PROJECT INFORMATION

ELLIOT ST (TH #446) (URBAN COLLECTOR) BRIDGE NO. 31

PROJECT DESCRIPTION: WORK TO BE PERFORMED UNDER THIS PROJECT INCLUDES THE REPLACEMENT OF THE EXISTING BRIDGE DECK INCLUDING RELATED APPROACH WORK.

**BRATTLEBORO
BF 2000(26)
PRE-CONTRACT PLANS**

MATERIAL TRANSITION DIAGRAM

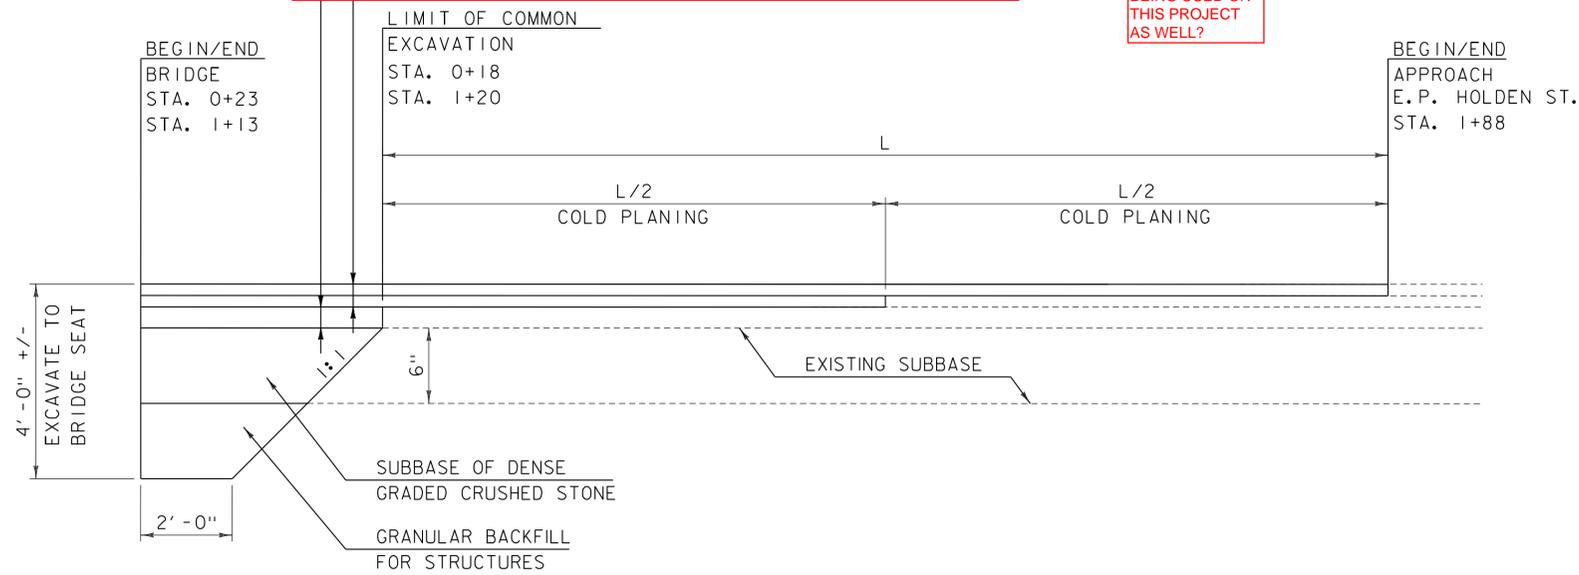
WHY IS THE BRIDGE MIX TYPE IVB NOT BEING USED ON THIS PROJECT AS WELL?

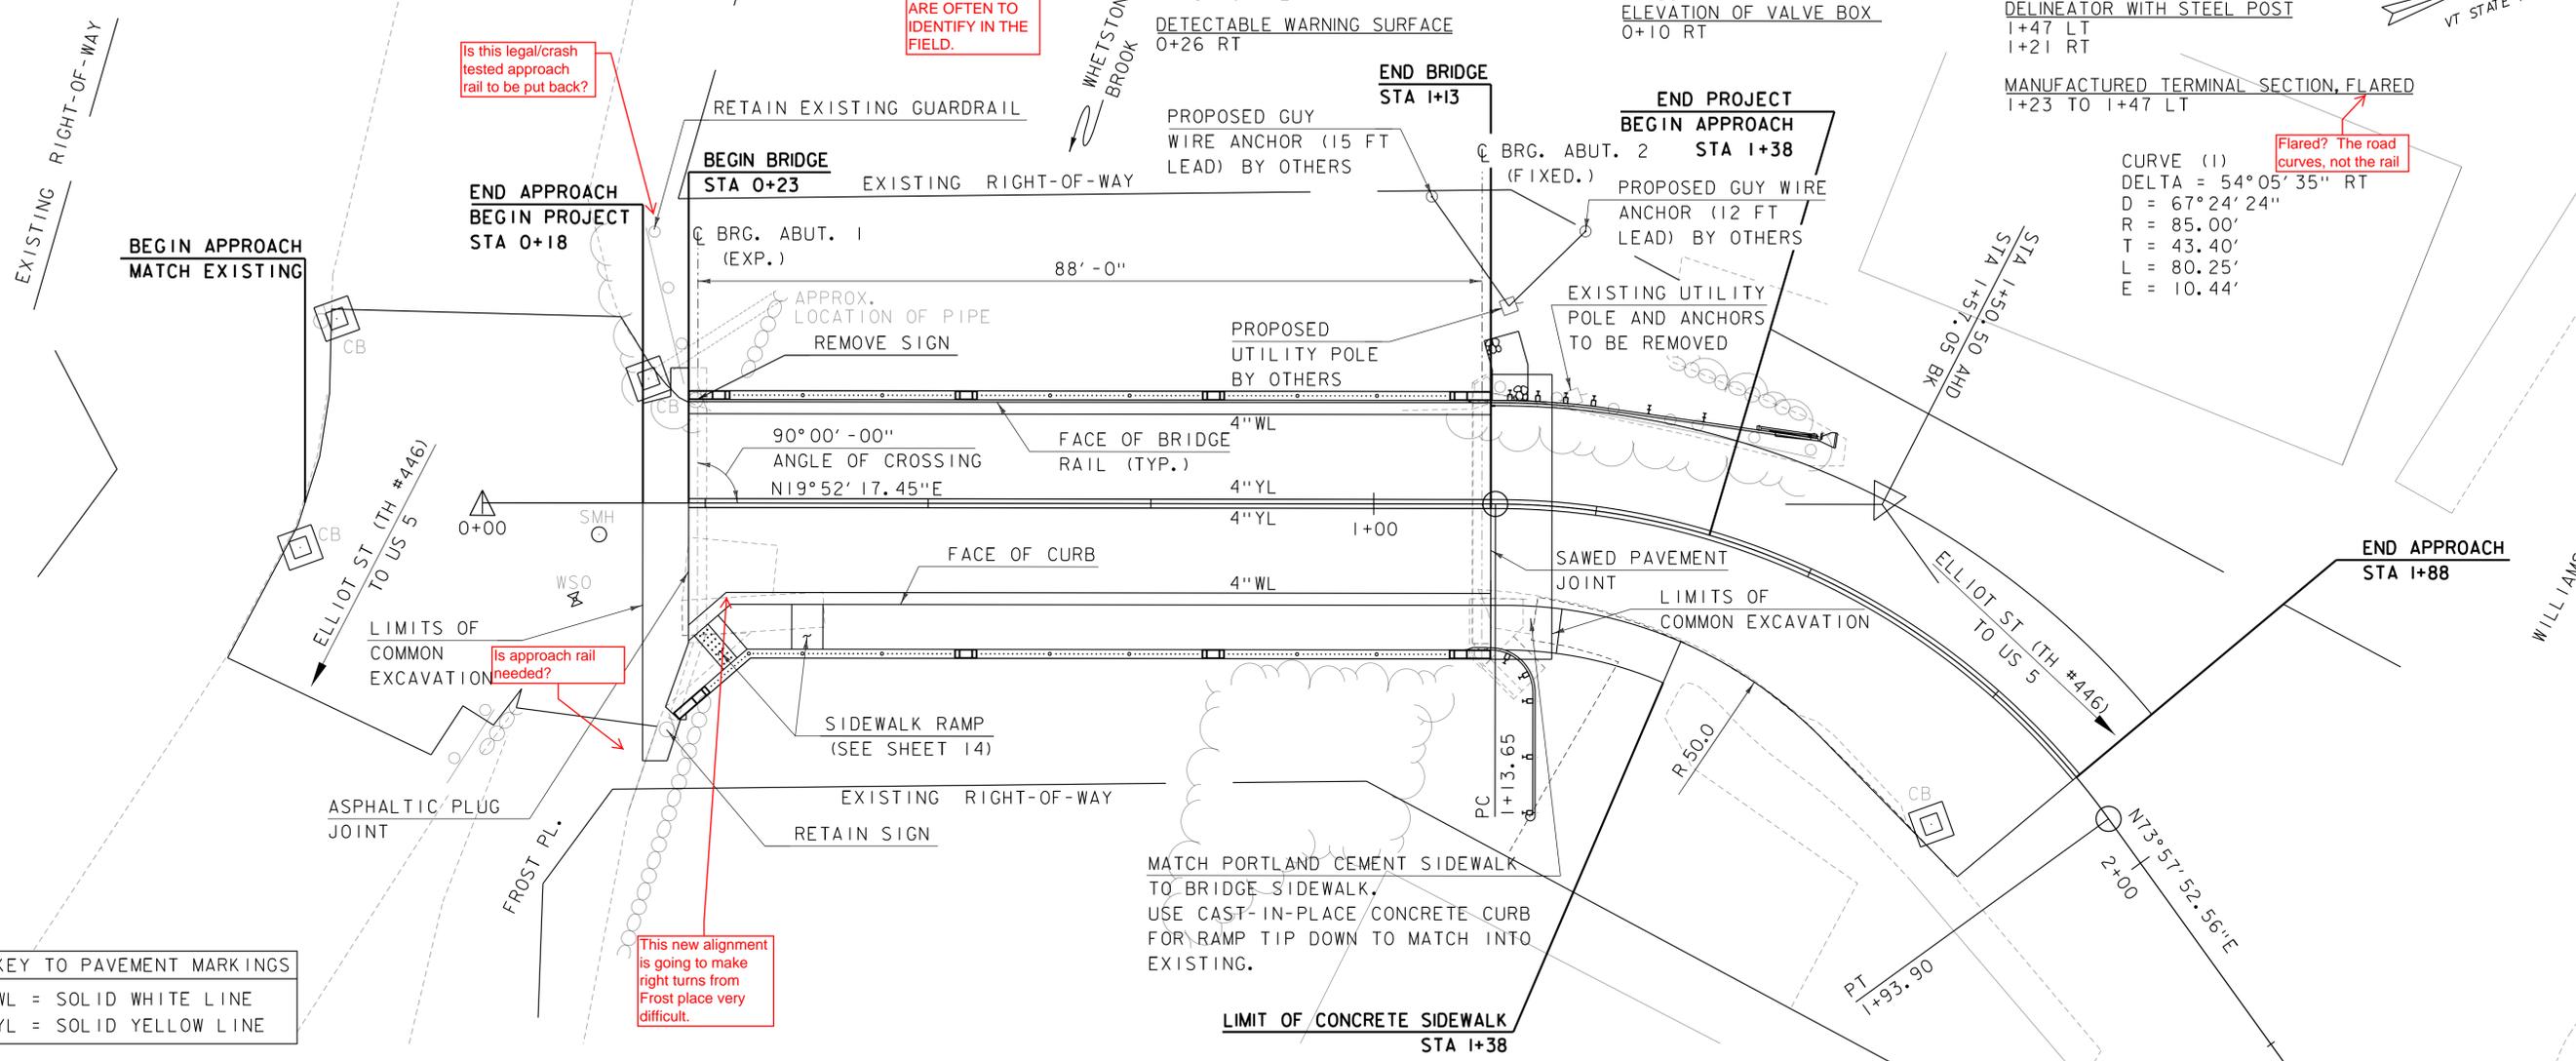
CAN YOU SHOW  
 THE SIGN WITH  
 STATION IN THE  
 LAYOUT? THESE  
 ARE OFTEN TO  
 IDENTIFY IN THE  
 FIELD.

This new alignment  
 is going to make  
 right turns from  
 Frost place very  
 difficult.

**BRIDGE RAIL ELEVATION (INTERIOR FACE)**

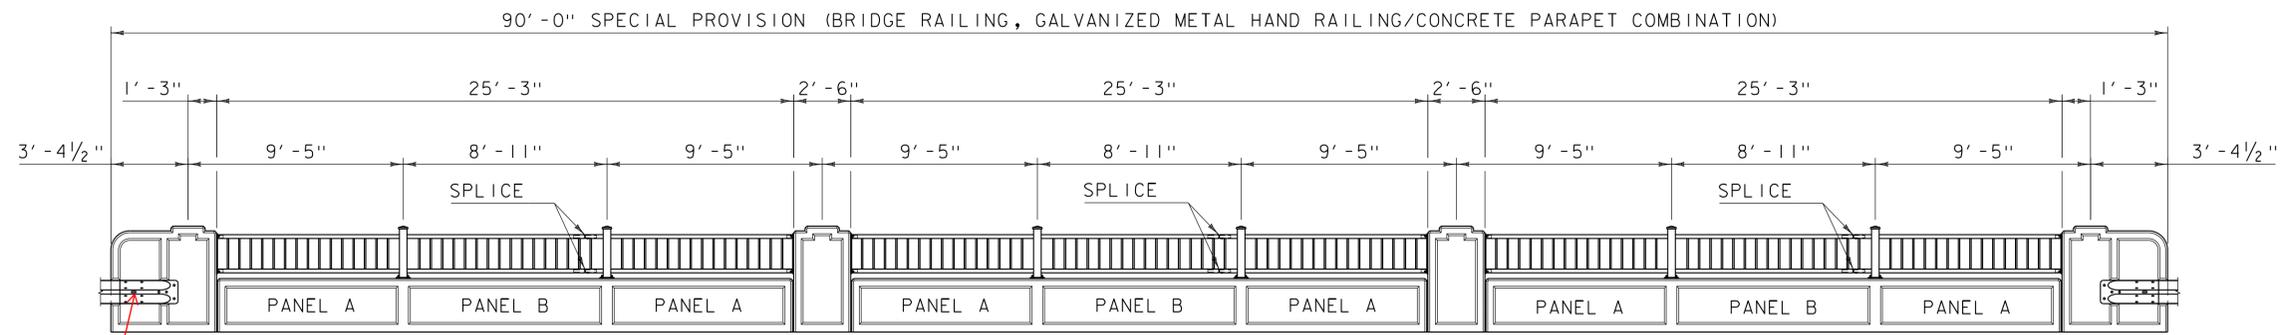
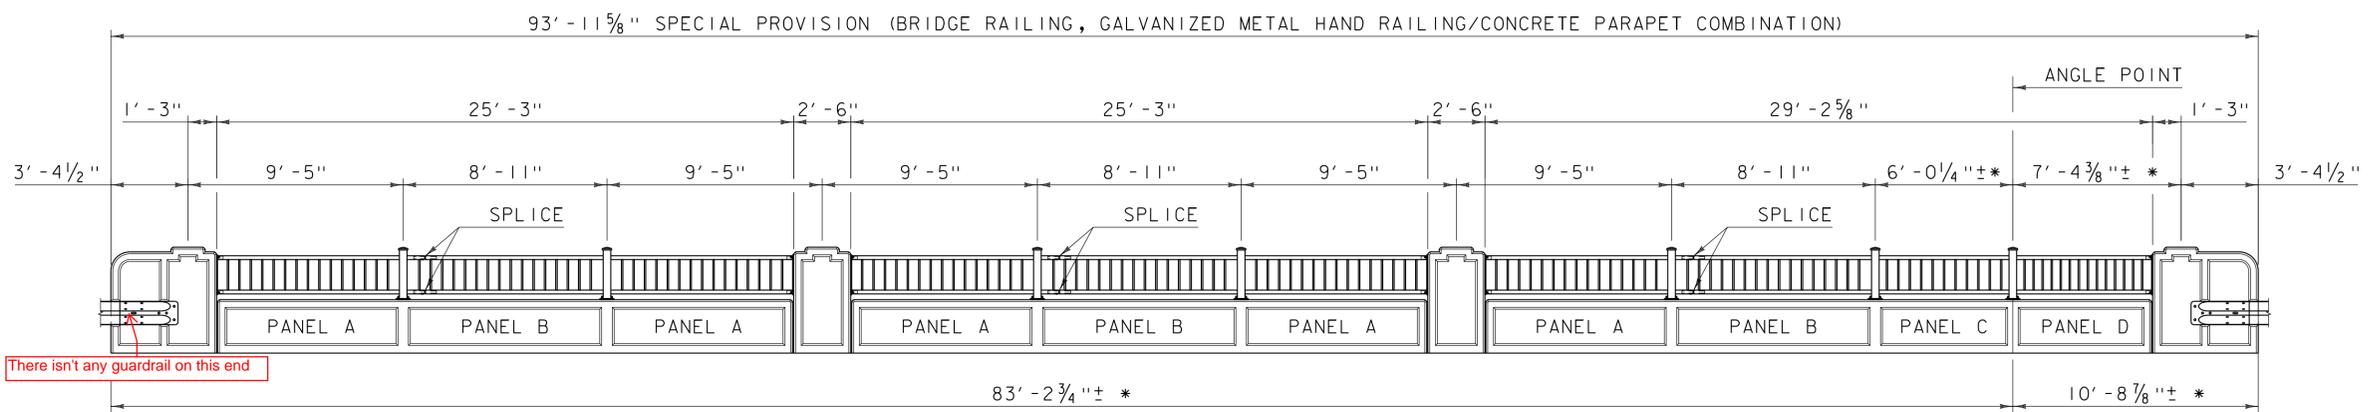
There isn't any guardrail on this end

There isn't any guardrail on this end

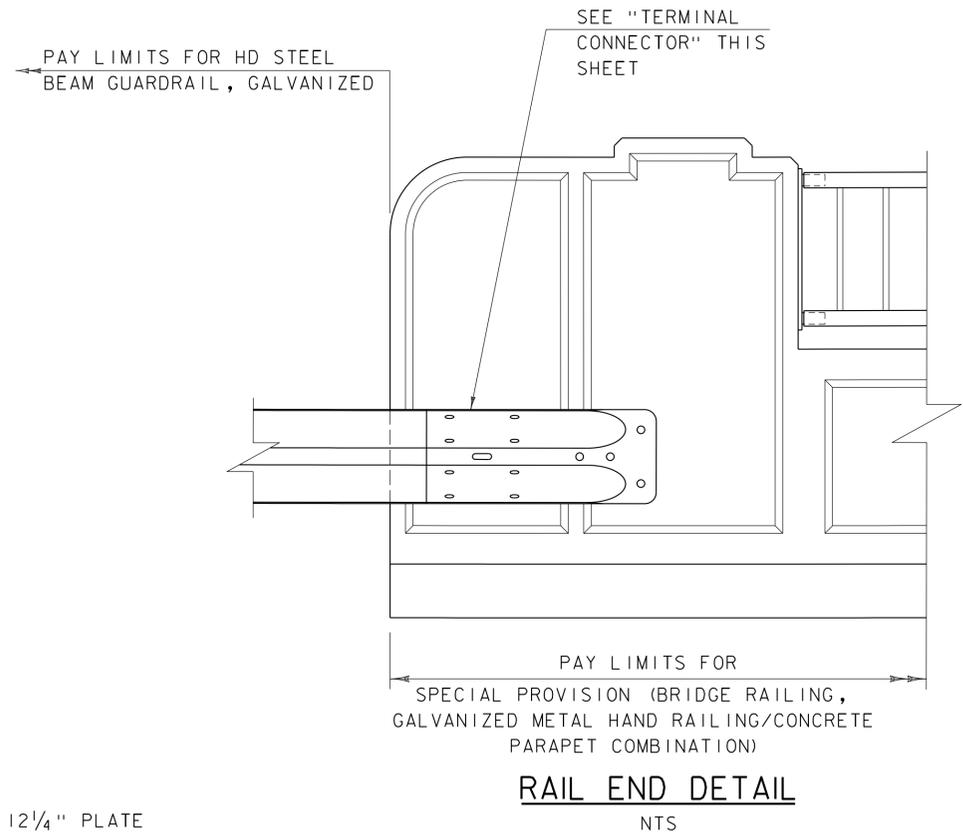
Specify size and type of bolts to be used in the terminal connector to connection plate connection.
